BioRID seating Observation from J-NCAP for GTR7

<u>September 10, 2013</u>

Purpose & Back ground

Observation of pelvis angle (J-NCAP)

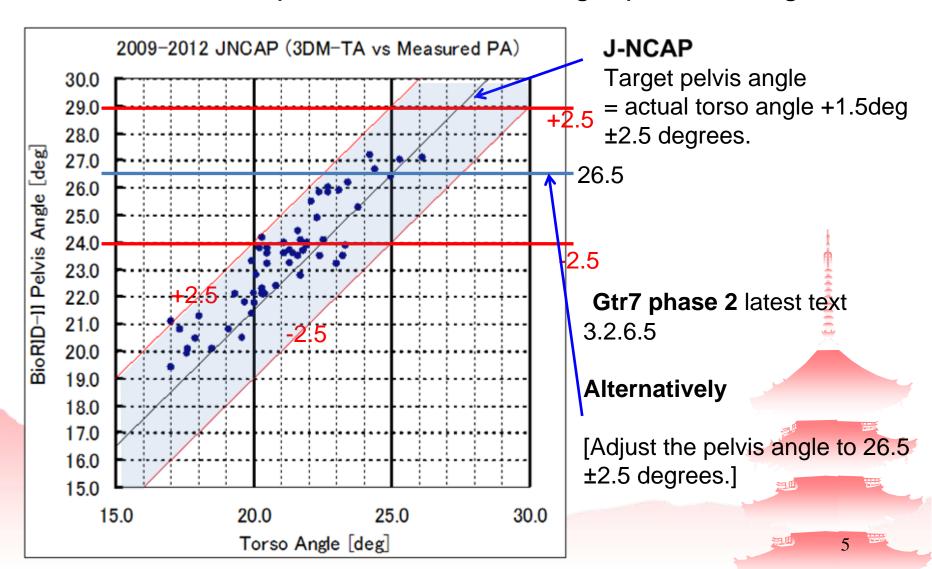
Condition: 3DM H-point, actual torso angle plus 1.5 deg

Observation of H-point (J-NCAP)

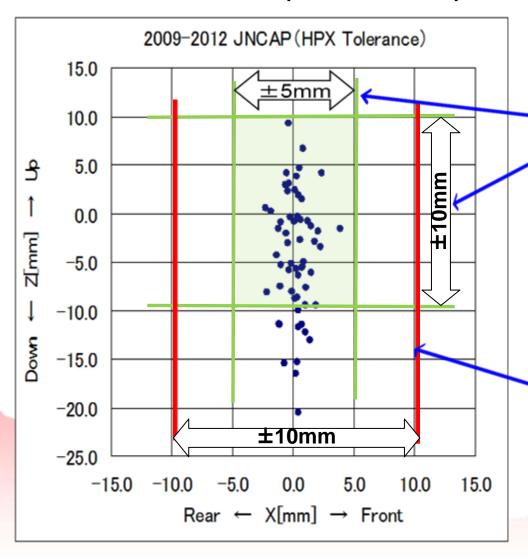
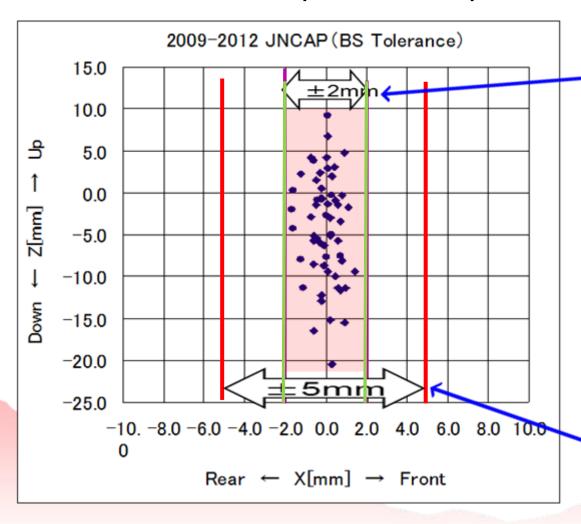
Condition: 3DM H-point, head position (H-point)

Target H-point, 20mm forward ±5mm.
Z ±10mm

3.2.6.6

H-point is positioned 20mm ±10mm forward of R50-point

Observation of backset (J-NCAP)

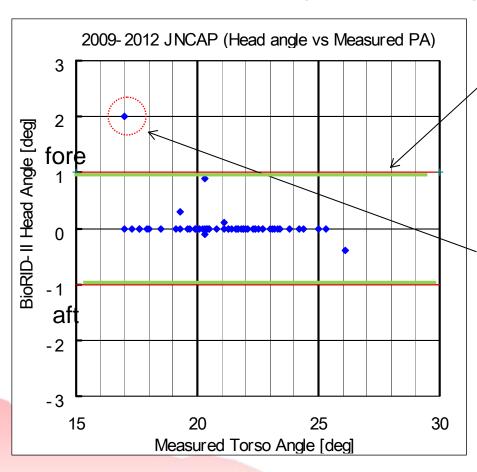
Condition: 3DM H-point, head position (backset)

Target backset ±2mm.

3.2.6.7

back of head §3.2.5.2 with a tolerance ±5mm
